CITY OF CONWAY, ARKANSAS HISTORIC DISTRICT COMMISSION

A. 527 Ash Street - Additions and Exterior Modifications (HDR-0721-0071)

527 Ash Street - Additions and Exterior Modifications

Old Conway Design Overlay District

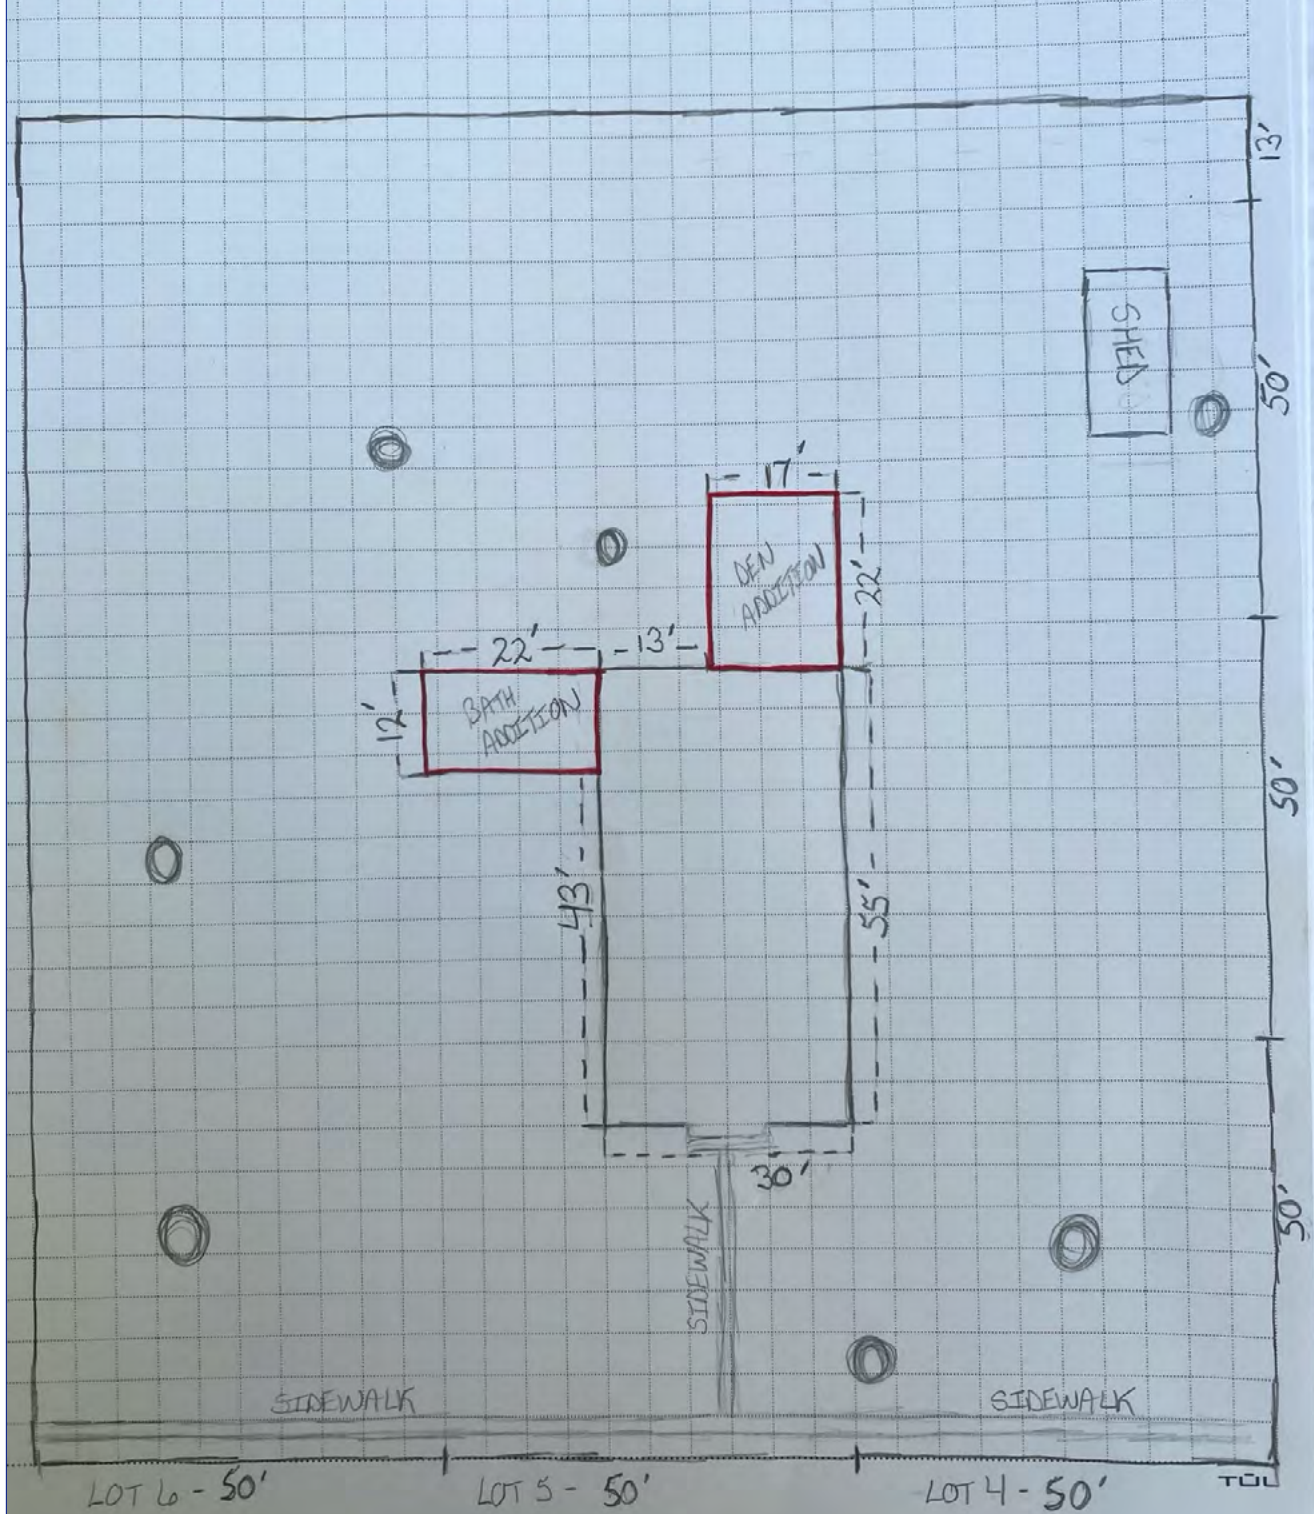
The proposed addition to the rear appears appropriate. The addition on the side of the structure (master bath) near the rear of the structure will radically alter the style and design of the structure. Recommend the master bath addition be required to be made parallel with the den addition to the rear of the structure. While this would require a significant tree to be removed, such tree is already diseased and is likely to be impacted by the den construction.

1. Require the master bathroom addition be moved to the rear of the structure, parallel with the den addition. This entails the removal of one significant tree on-site.
2. Require true divided light windows or one over one windows.
3. Require the additions to be of wood, Hardieboard, or LP smartside.
4. Require fascia and soffits to be finished with wood construction.
5. HVAC equipment be placed in a manner to minimize its visibility from the street.
6. The applicant will provide revised plans to the Planning Director for review and approval prior to issuance of building permits.

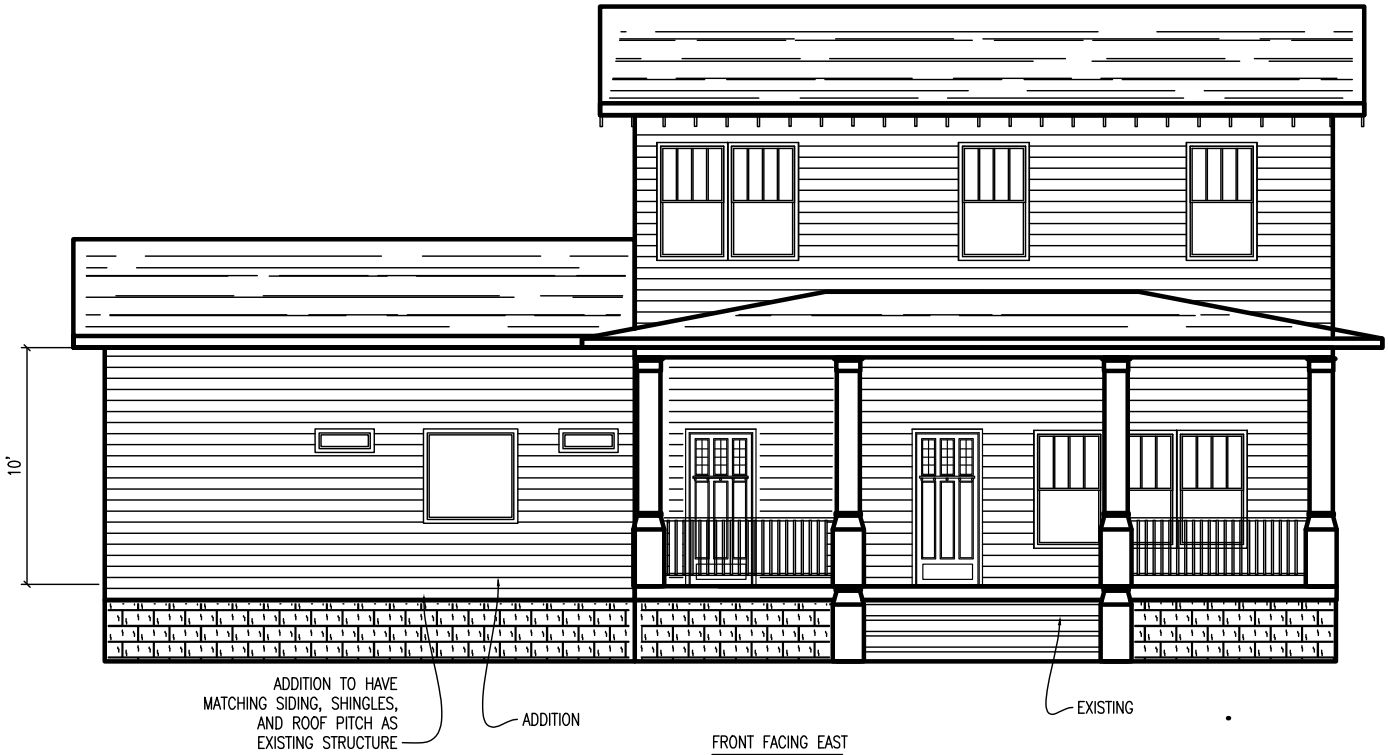
The bathroom addition will be visible from the public right-of-way on the south side of the existing residence.

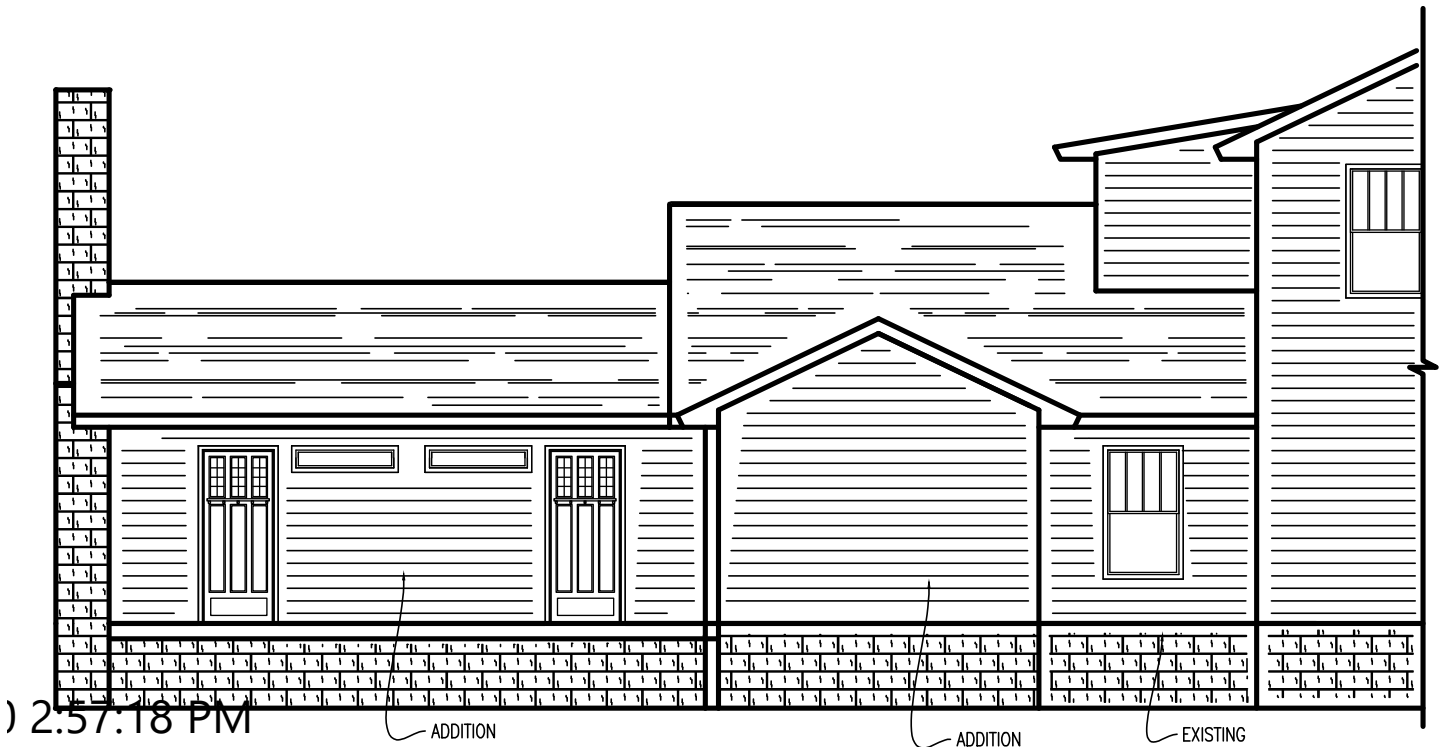
The bathroom addition will connect to the existing residence where the back three windows are currently located. The den addition will be visible from this view as well.

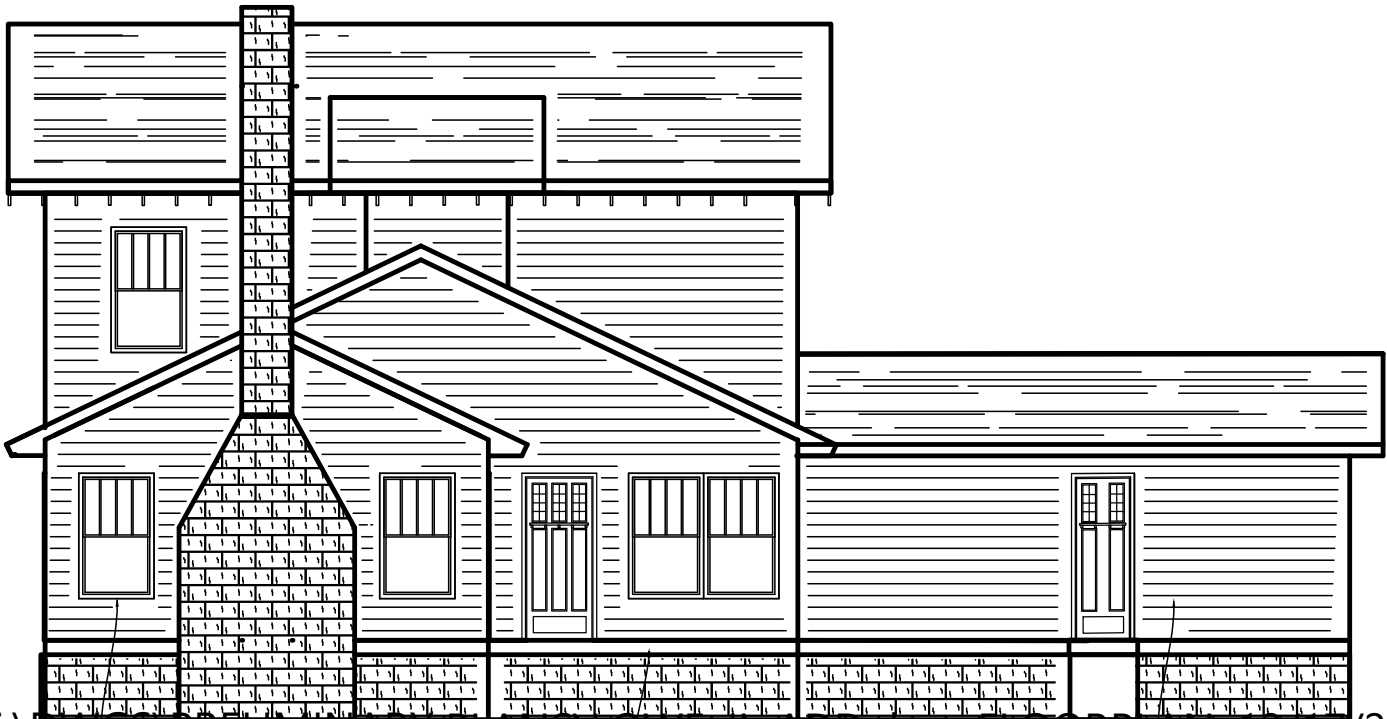
The den addition is to be built where the rear deck is currently located.
